Determination 2005/29

Appropriate privacy for single sex toilets at a co-educational school

Figure A: Toilets 1.10 and 1.11
(architect's plan)

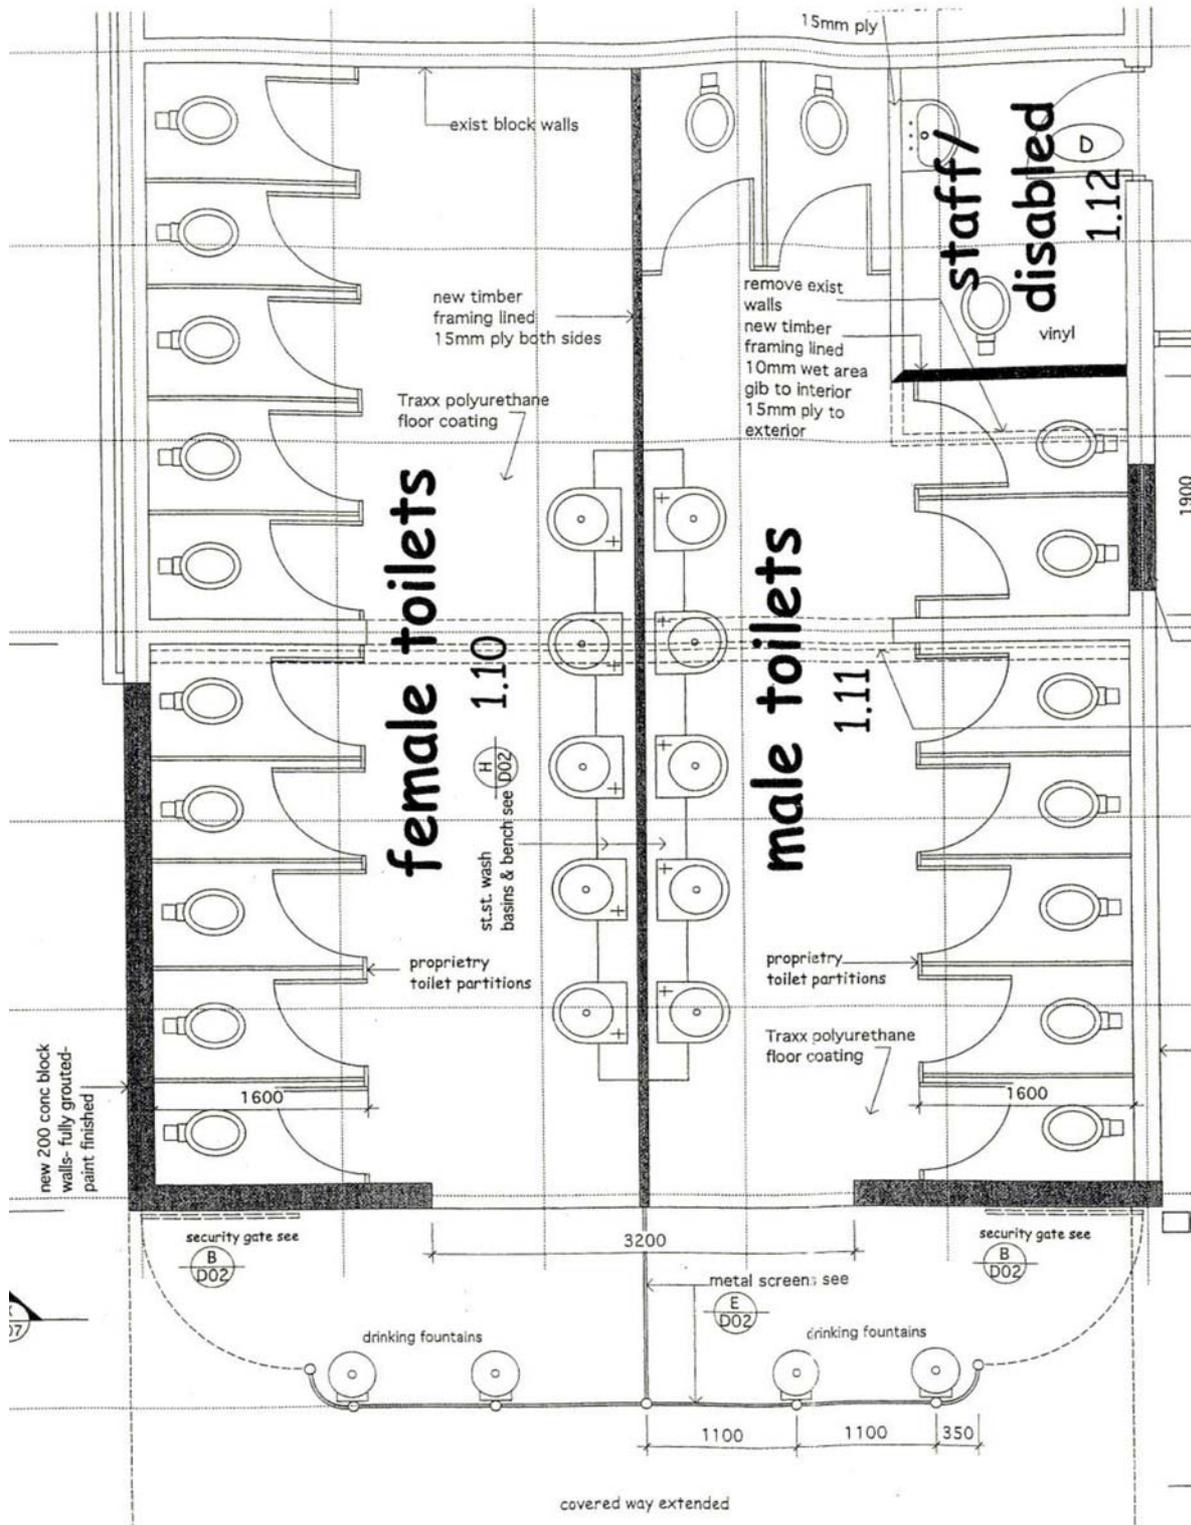
- “2. Within that application, sanitary facilities have been provided which permitted a direct line of sight through a perforated metal screen between a general public area and WCs, contrary to the provision of the Building Code clause G1.3.2(d), the provisions of the Acceptable Solutions G1/AS1 Clause 6.1.1 and Figure 10.

- “4. Council remains of the view that the proposed perforated screening to both male and female spaces containing soil fixtures (toilet and hand basins) fails to comply with both the Building Code and the Acceptable Solution as the screening fails to prevent direct line of sight between a general public area and a space containing toilet fixtures.”

- 6.2.4 Given the thickness of the metal screens and the diameter of the perforations, consideration of Figure A shows that the screens do not block lines of sight from general public areas to WCs in Toilet 1.11, nor from the lobbies of Toilets 1.10 and 1.11 to WCs in Toilets 1.11 and 1.10 respectively. However, consideration of Figure B shows that there is no line of sight from the general public area to a WC in Toilet 1.21.

6.2.6 I accordingly conclude that Toilets 1.10 and 1.11 do not comply with G1/AS1, but that Toilet 1.21 as drawn by the architect does comply (in other words, the territorial authority’s annotations may be ignored).

- (a) Determine that:
 - (i) Toilets 1.10 and 1.11 do not comply with clause G1.3.2(d) of the building code; and
 - (ii) Toilet 1.21 does comply with clause G1.3.2(d) of the building code.
- (b) Confirm the territorial authority’s decision to refuse to issue a code compliance certificate in respect of Toilets 1.10 and 1.11.
- (c) Reverse the territorial authority’s decision to refuse to issue a code compliance certificate in respect of Toilet 1.21.
